1101 H STREET NE / PUBLIC SPACE PERMIT #380565

FEBRUARY 24, 2022

The following Architectural drawings dated 02.03.22 and submitted to DCRA under building permit #B2109279 are provided to address the open comments for public space permit #380565. Additional dimensions and notes have been added for clarity per the comments below, but no changes to the drainage, projections, overhangs, etc. have been made to the building permit drawings.

2ND - 6TH FLOOR
PLANS

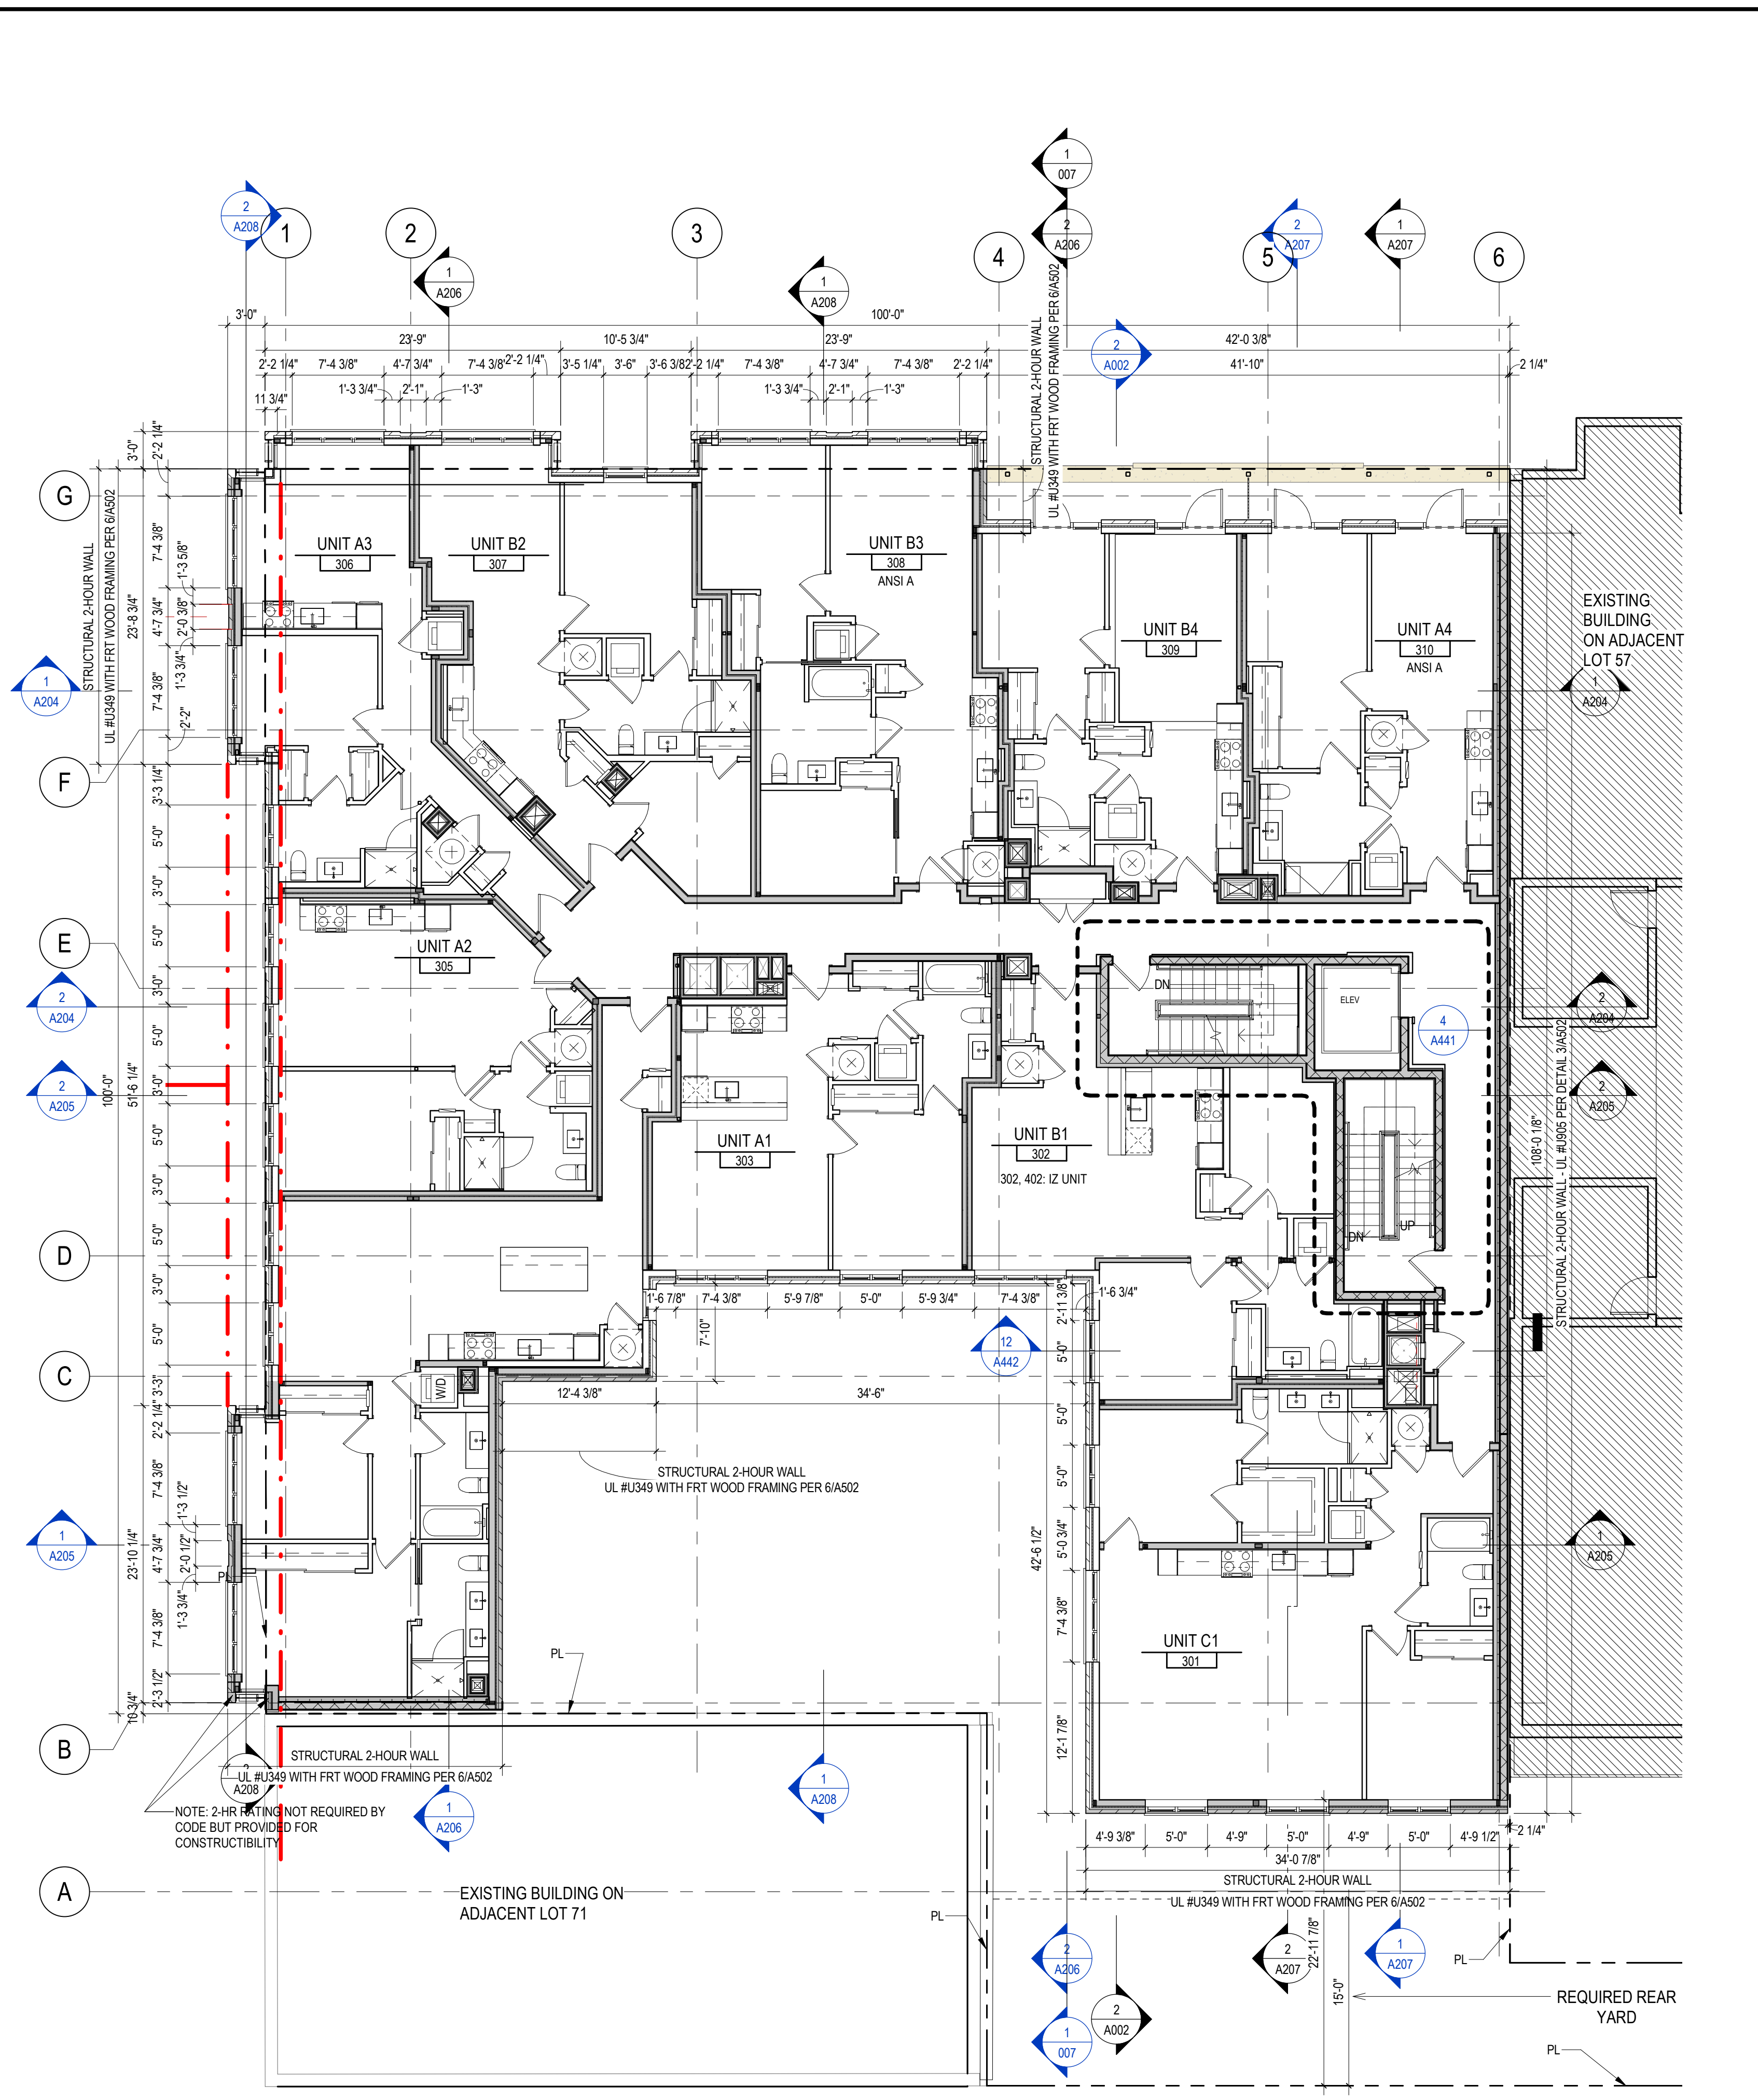
Reviewer	Description	Sheet References
IPMA/ Stormwater	Provide drainage information, including grading, drainage areas, inlets, and downspout locations to demonstrate that no impervious areas drain to the public space.	<p>A102 – 2nd – 6th Floor Plan shows dimensions for the projecting bays. 2ND Floor indicates terrace drainage is internal to property and no impervious areas spill to public way.</p> <p>A104 – Penthouse & Penthouse Roof Plan indicates roof drainage is internal to property and no impervious areas spill to public way. Downspouts from Penthouse roof to penthouse interior drains are indicated.</p> <p>A501 – Exterior Sections indicate impervious canopy drainage is directed to interior of building rather than public way.</p>
OP – Urban Design	<p>Provide additional floor plans that show parking locations and access route, so that OP can fully review the location and design of the proposed curb cut. Curb returns for the driveway must remain within the lot line extended to the curb. Curb returns may not cross over into the public space that is in front of an adjacent property.</p> <p>Please submit elevations, sections, and other relevant details regarding the proposed building projections and overhangs. Per the DCMR Title 12A Section 3202.7.1.1, building projections must maintain a minimum of 12' offset from streets with a right-of-way width of 90', such as H Street NE. Please reduce projecting distance of the proposed bay windows on H Street to maintain a minimum 12' from the curb line. OP</p>	<p>003 – Site Plan indicates dimensions from curb to projecting bay at H Street NE provided as 12'-0 3/8" minimum, and 24'-10 1/8" at 11th Street NE. note: Curb cut at driveway extends past the lot line when extended to the curb due to existing site constraints and is under review with DDOT.</p> <p>A101 – 1st Floor and Cellar Plan shows parking locations and access route.</p> <p>A102 – 2nd – 6th Floor Plan shows dimensions for the projecting bays. 2ND Floor indicates terrace drainage is</p>

Refer to sheet A102, which shows 2nd floor indicates terrace drainage is internal to property and no impervious areas spill to public way. Refer to sheet A104 which indicates roof drainage is internal to property and no impervious areas spill to public way. Downspouts from Penthouse roof to penthouse interior drains are indicated. Refer to sheet A501, which indicates impervious canopy drainage is directed to interior of building rather than public way.

parking locations and access route. Sheet A102 shows dimensions for the projecting bays. Sheets A201, A204, and A208 indicate the extent of projecting bays.
